**CERTIFICATE OF APPROPRIATENESS**

**Property:** 8734 Glenloch Drive, Lot 4, Block 52, Glenbrook Valley Section 9 Subdivision. The property includes a historic 2,282 square foot, one-story brick veneer single-family residence with attached garage situated on a 9,040 square foot (80' x 113') corner lot.

**Proposal:** Alteration – In July 2014 the applicant replaced 14 original aluminum single lite fixed windows, 2 and 3-part single lite slider windows with 11, 9-lite slider, 6-over-6 sash windows, and a 3-part bay window, replaced the front entry door with a 9-lite front entry door, installed inoperable shutters, and replace the sectional overhead garage door with a new garage door without a City Permit or Certificate of Appropriateness.

**Recommendation:** Approval with conditions:

**NORTH SIDE ELEVATION**

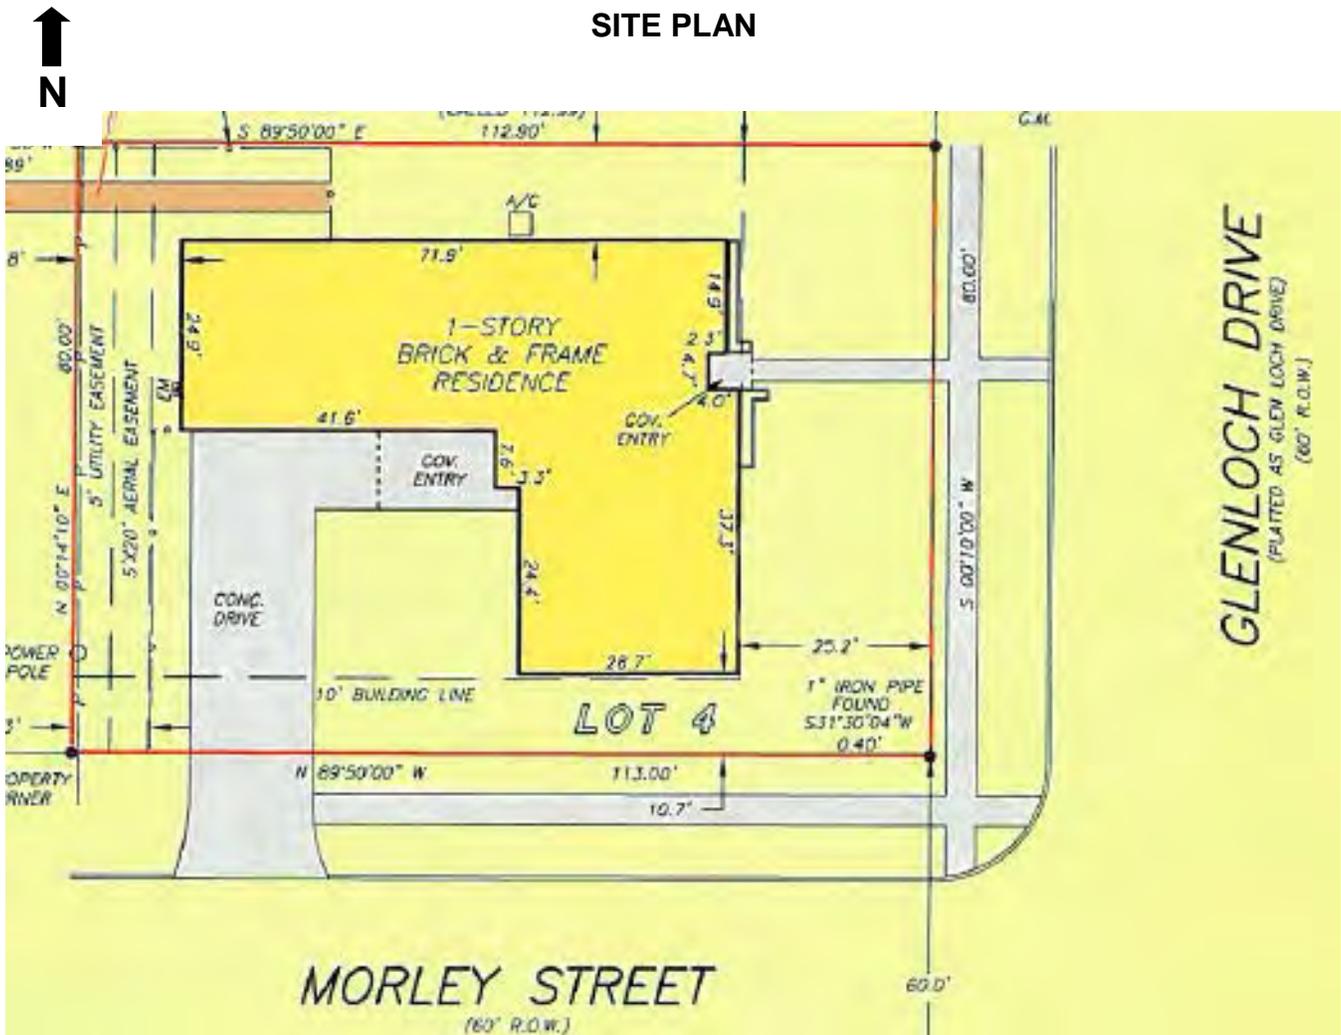
|                                     | <input checked="" type="checkbox"/> | <input type="checkbox"/>            | (1) The proposed activity must retain and preserve the historical character of the property;<br><i>The removal of the original aluminum windows and entry door results in the loss of historic material. The new divide lite windows along with the installation of the bay window alter the historic character of the Traditional Ranch.</i>   |
| <input type="checkbox"/>            | <input checked="" type="checkbox"/> | <input type="checkbox"/>            | (3) The proposed activity must recognize the building, structure, object or site as a product of its own time and avoid alterations that seek to create an earlier or later appearance;<br><i>The installation divided lite craftsman style windows, shutters and bay window introduces new architectural features that are not compatible with and alter the character of the 1959 Traditional ranch.</i>  |
| <input type="checkbox"/>            | <input checked="" type="checkbox"/> | <input type="checkbox"/>            | (4) The proposed activity must preserve the distinguishing qualities or character of the building, structure, object or site and its environment;<br><i>The original aluminum windows and solid entry door were a distinguishing part of the character of the Traditional Ranch residence. The replacement of the material results in the loss of historic material and alters the character of the residence.</i>  |
| <input type="checkbox"/>            | <input checked="" type="checkbox"/> | <input type="checkbox"/>            | (5) The proposed activity must maintain or replicate distinctive stylistic exterior features or examples of skilled craftsmanship that characterize the building, structure, object or site;<br><i>The replacement of the single lite aluminum windows with divide lite sash and slider windows and the replacement of the solid entry door with a 9-lite entry door do not replicate the original simple single lite windows and entry door.</i>   |

**Replace the existing 9-lite slider and divided lite sash windows with single- lite slider windows and 1-over-1 sash windows, remove the bay window and install 3, single lite windows to match the original condition; remove the inoperable shutters; replace the existing 9-lite entry door with an appropriate traditional ranch style door.**

FIRST FLOOR PLAN WITH WINDOW LOCATIONS

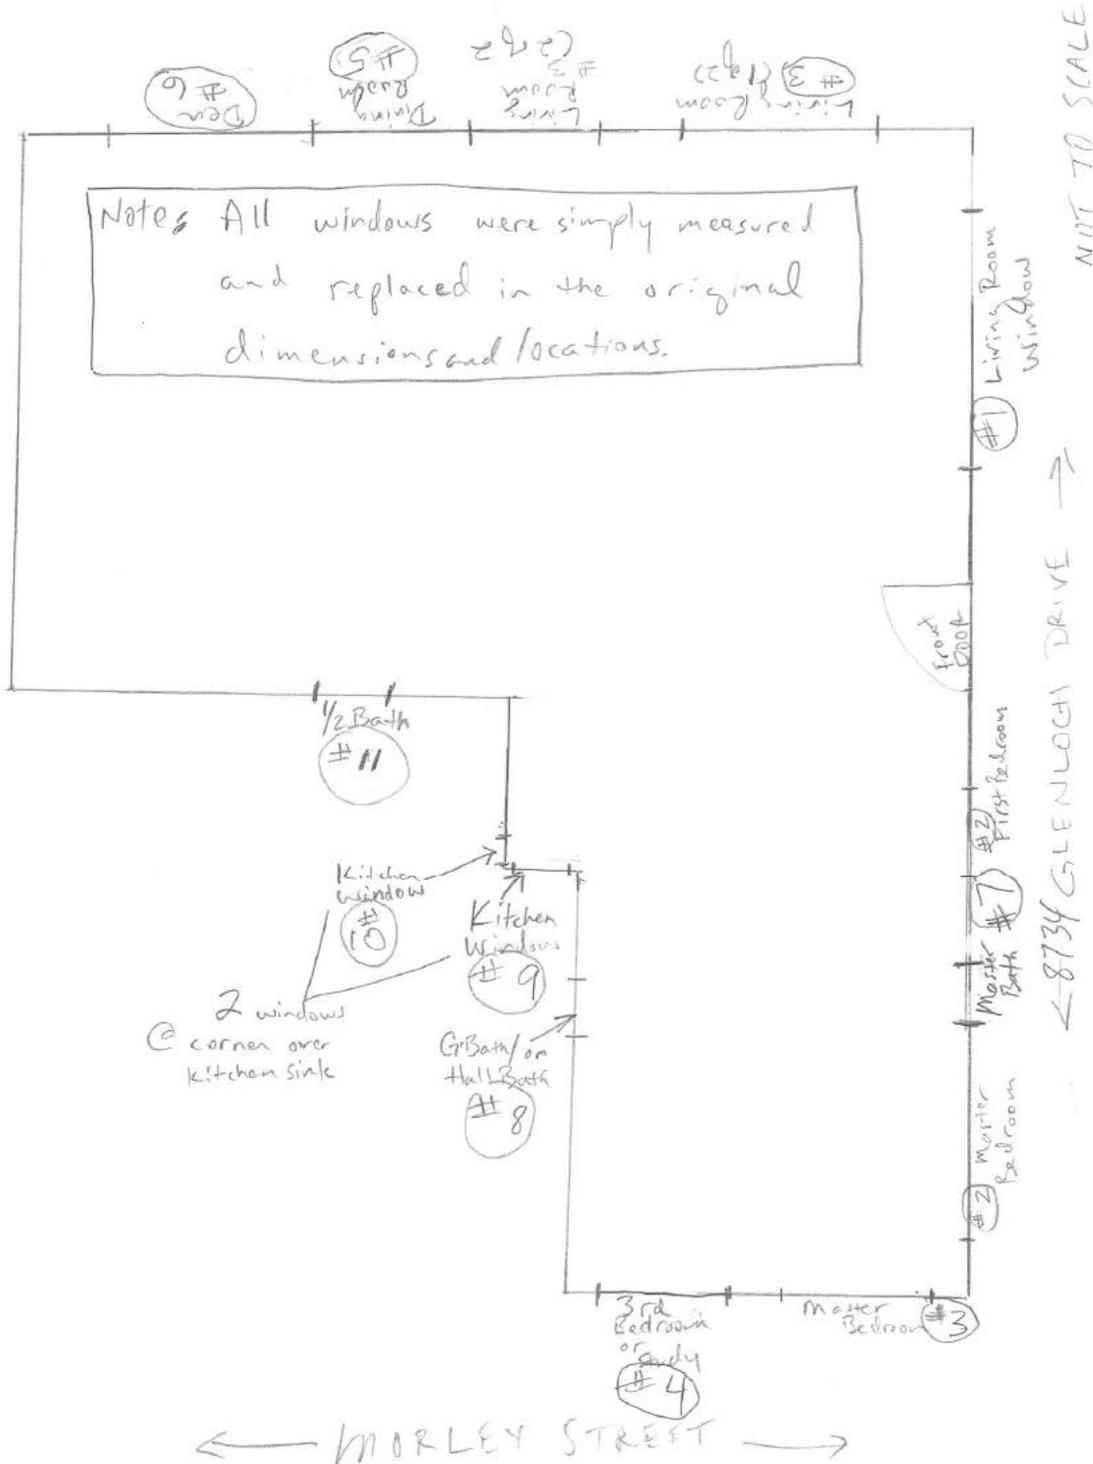
**Front Elevation:** Three single lite fixed windows were replaced with a 3-part bay window consisting of two 9-over-9 sash windows and a 9-lite picture window. The solid entry door was replaced with a 9-lite entry door. Two, 3-part windows were replaced with two 3-part 9-lite slider windows; a fixed window was replaced with a 6-over-6 sash window.

**Side Elevation:** A 2-lite slider window was replaced with a 2-part 9-lite slider window; a 3-part slider window was replaced with a 3-part 9-lite slider window. Two fixed windows were replaced with two 6-over-6 sash windows. The sectional overhead garage door was replaced with a new metal sectional overhead garage door,
